UNITED STATES PATENT AND TRADEMARK OFFICE

| APPLICATION NO. | FILING DATE | FIRST NAMED INVENTOR | ATTORNEY DOCKET NO. | CONFIRMATION NO. |
|-----------------|-------------|-----------------------|---------------------|------------------|
| 10/762,772 | 01/22/2004 | Stephen W. Briggs III | BBMED.004A | 3108 |

| Office Action Summary | Application No. 10/762,772 | Applicant(s) BRIGGS, STEPHEN W. | |

DETAILED ACTION

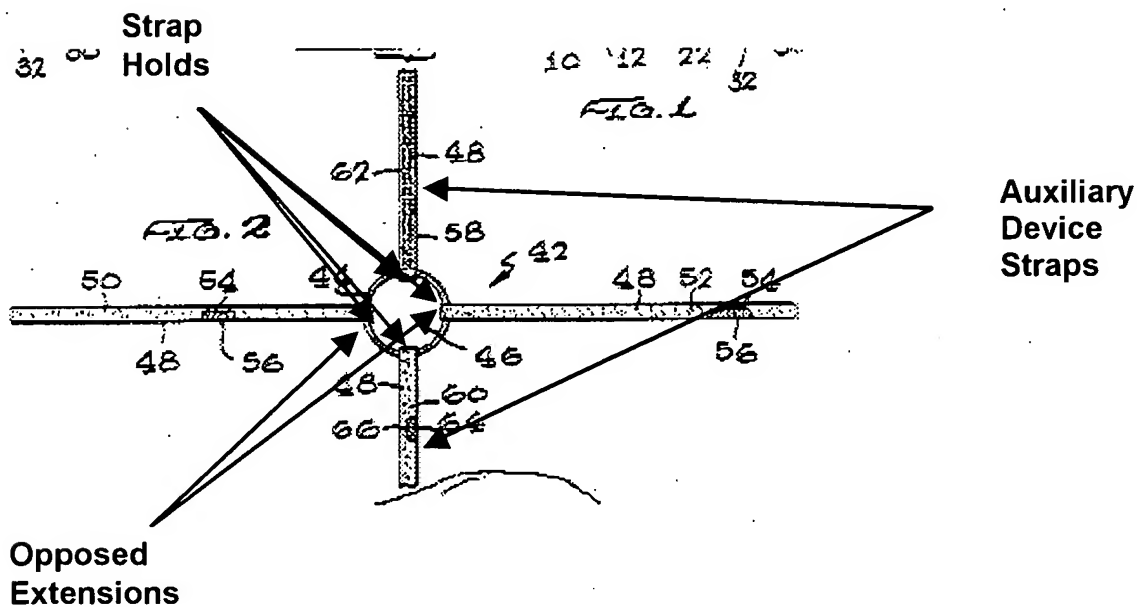
- a ring (44) having a pair of opposed extensions defining strap holds (Col. 3, lines 36-48), and further having a pair of secondary strap holds (see illustration of Fig. 2 below); a void (46) within the ring (44) configured to allow passage of a tracheostomy tube (38) through the ring (44);

- a pair of auxiliary device straps (see illustration of Fig. 2 below) affixed to each of the secondary strap holds, the auxiliary straps configured so that when the tracheostomy tube extends through the ring void (46), the auxiliary straps extend around an auxiliary device (40) that is fit onto the tracheostomy tube (Fig. 5) so as to maintain a maximum spatial relationship between the auxiliary device and the ring (44).

With respect to claim 12, Briggs discloses a ring (44) having an aperture (46), a pair of opposed primary strap holds, and a pair of secondary strap holds (see illustration of Fig. 1 above); and a pair of auxiliary device straps affixed to each of the secondary strap holds, the auxiliary straps configured so that, when the tracheostomy tube extends through the ring void, the auxiliary straps can extend around an auxiliary device that is
